Service Note

Product	Description:	Service note no.
M2000	Wrong placement of D18	720 10 T010

Correct placement of D18

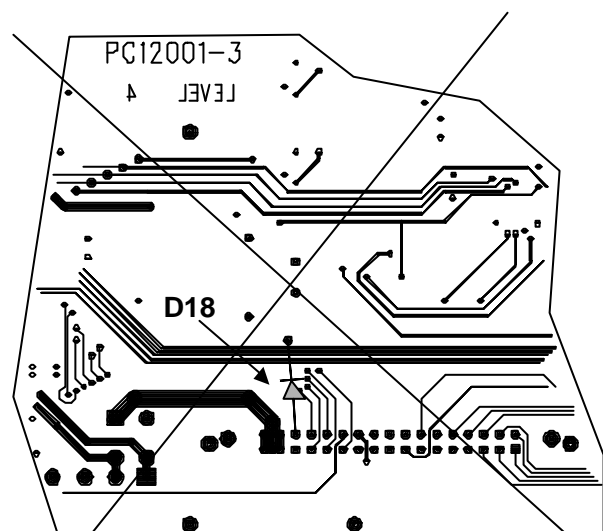
This service note only concerns units with serial no. between 1105281 and 1105380. A few units in the above mentioned serial no. area might have wrong placement of the diode D18, which is mounted on the solder side of the main board. Modification should only be carried out by skilled technicians.

The M2000 cannot start up, the backlight is on, but there is no text on the display. Or the unit cannot lock to digital input. The symptoms might be intermittent.

1. Turn Off Power and Disconnect Power Cord.
2. Dismount the top lid.
3. Check the white label on the main board.
If it reads B5642 or B5677, please continue this procedure.
But if it reads something else, the placement of the diode is already correct.
4. Dismount the main board in this way:
 - a. Disconnect front connection, J2.
 - b. Remove screws at MT7, MT8, MT2 on the main board.
 - c. Remove screws at the XLR connectors on the back panel.
 - d. Remove screw at SPDIF in/out connector.
 - e. Remove jack nut at PEDAL IN.
 - f. Push the main board into the front profile a little to free the connectors from the backpanel, then lift out the board.
5. Check the placement of D18 on the solder side of the main board, see figures below.
